US 30 (Baseline Road)

IL 47 to IL 31

Community Advisory Group Meeting

December 4, 2014

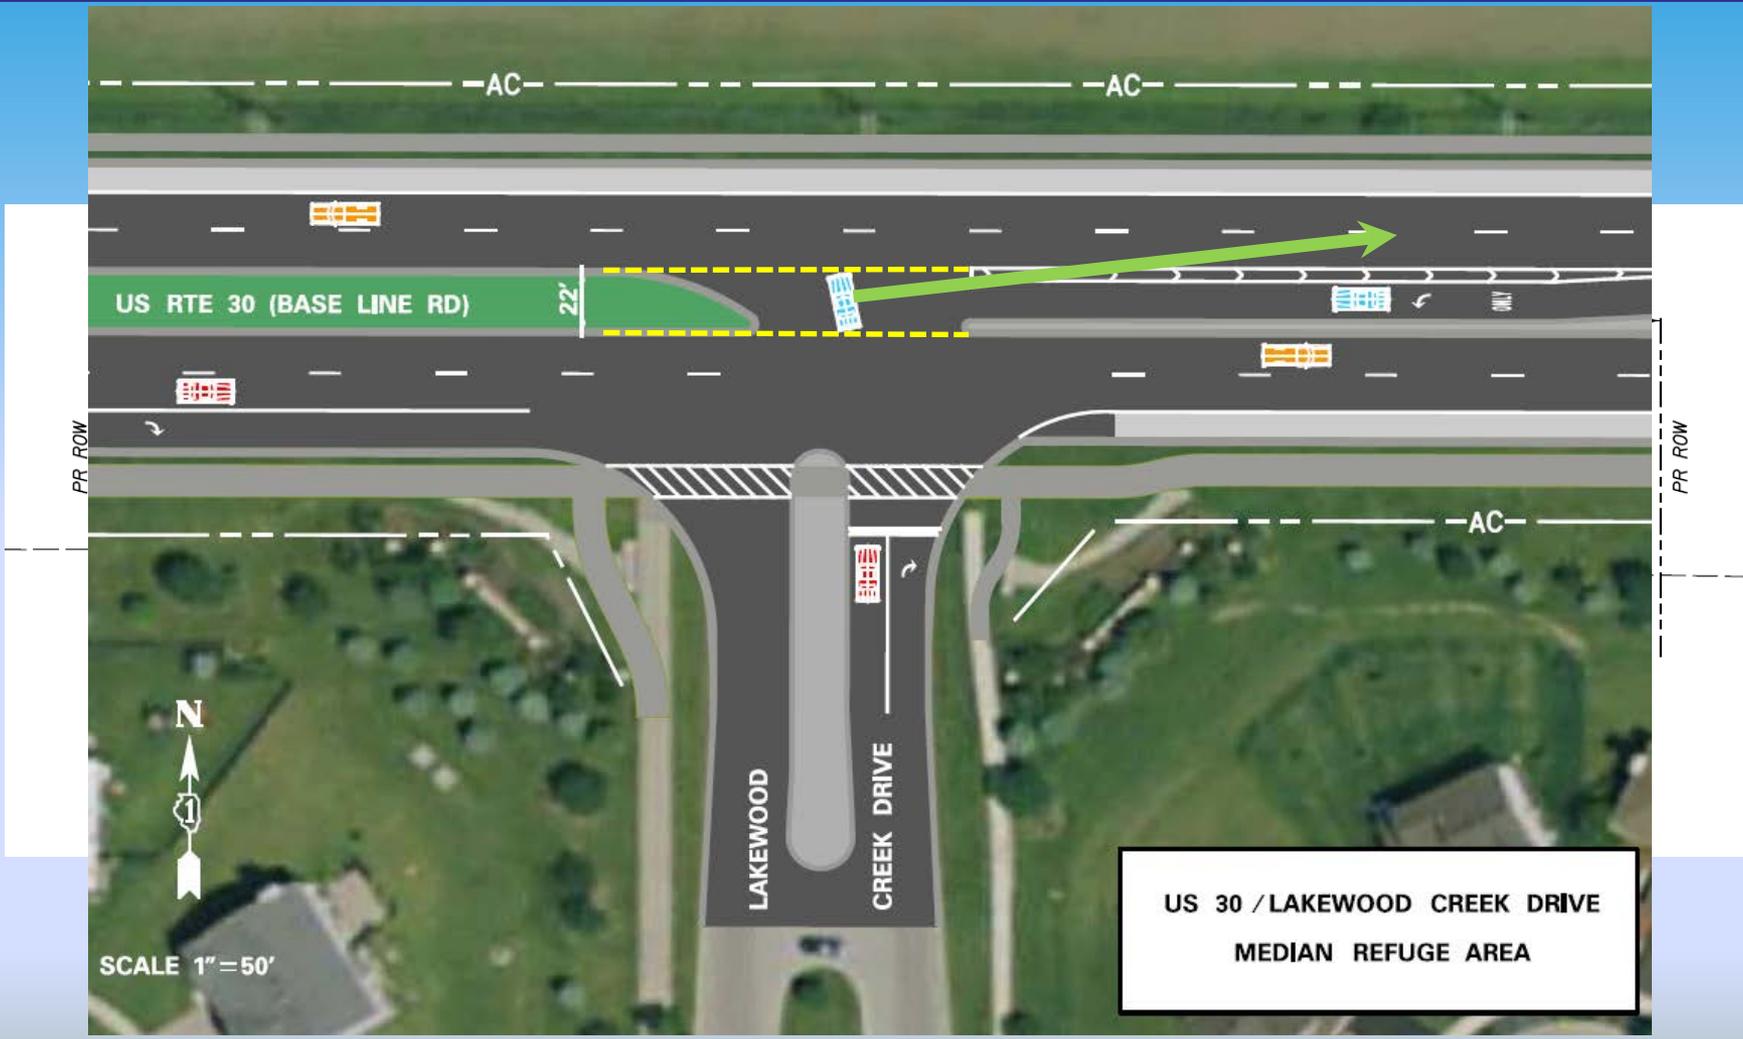
- Minimize the ROW width in order to protect the existing landscape buffers
- Look more closely at options to reduce the required ROW, we would especially ask that you consider a significant reduction in the center median width.
